Proposed Modification to Project Approval 07_0127

Invincible Colliery Open Cut Mine

February 2009 Ref No. 708/19

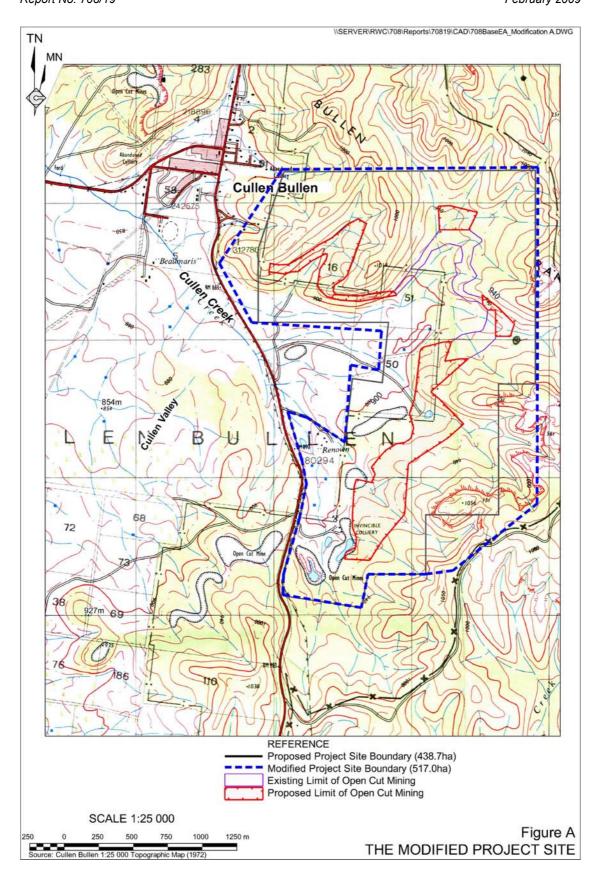
Coalpac proposes to rationalise the configuration of the eastern and northwestern boundaries of the Invincible Colliery as illustrated on **Figure A**.

The following provides a summary of the proposed modification to the configuration of the eastern boundary.

- The proposed modification to the configuration of the eastern boundary occurs only within the Ben Bullen State Forest, ie. there is no privately owned land involved

- The proposed modification to the configuration of the eastern boundary would increase the area contained within the Project Site by 10.9ha.
- The proposed modification to the configuration of the northeastern boundary occurs within the Ben Bullen State Forest and freehold land for which purchase by Coalpac has been negotiated.

- The proposed modification to the configuration of the northeastern boundary would increase the area contained within the Project Site by 4.8ha
- The modified Project Site boundary remains entirely within the Macquarie River catchment (with the triangular excision from the southeastern corner of the Project Site occurring (in part) within the Cox's River catchment, ie. the Sydney Drinking Water Catchment).

Figure 1: Project Site and Mine Layout

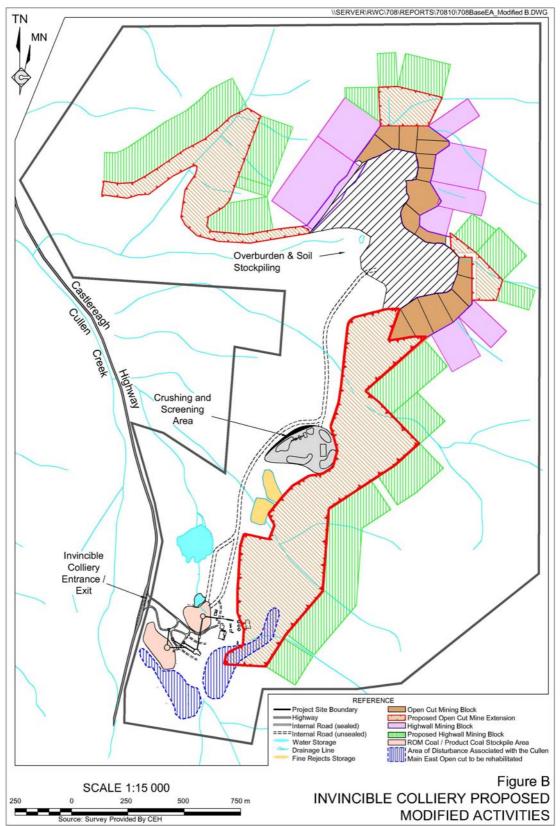
Coalpac Pty Ltd ("Coalpac") is seeking a second modification to PA 07_0127 to revise the "Project Site Boundary" identified in the Project Maps of Appendix 1, ie. Figure 1 – Project Site and Mine Layout (p. 20), Figure 2 – Coal Transport Routes (p. 21), Figure 5 – Proposed Final Landform and Mine Rehabilitation Plans (p. 24). The proposed modification would be administrative in nature and has been proposed to rationalise the eastern boundary of the Invincible Colliery to aide in the definition, creation and management of mining tenure over the site.

On the basis of the preceding, the proposed modification would have no influence on the environmental impact of the approved development. The modification would be administrative only and could be affected through revision to *Figures 1*, 2 and 5 of PA 07_0127. Modified versions of *Figures 1*, 2 and 5 have been attached to this document and provided as individual electronic files for incorporation into the modified project approval.
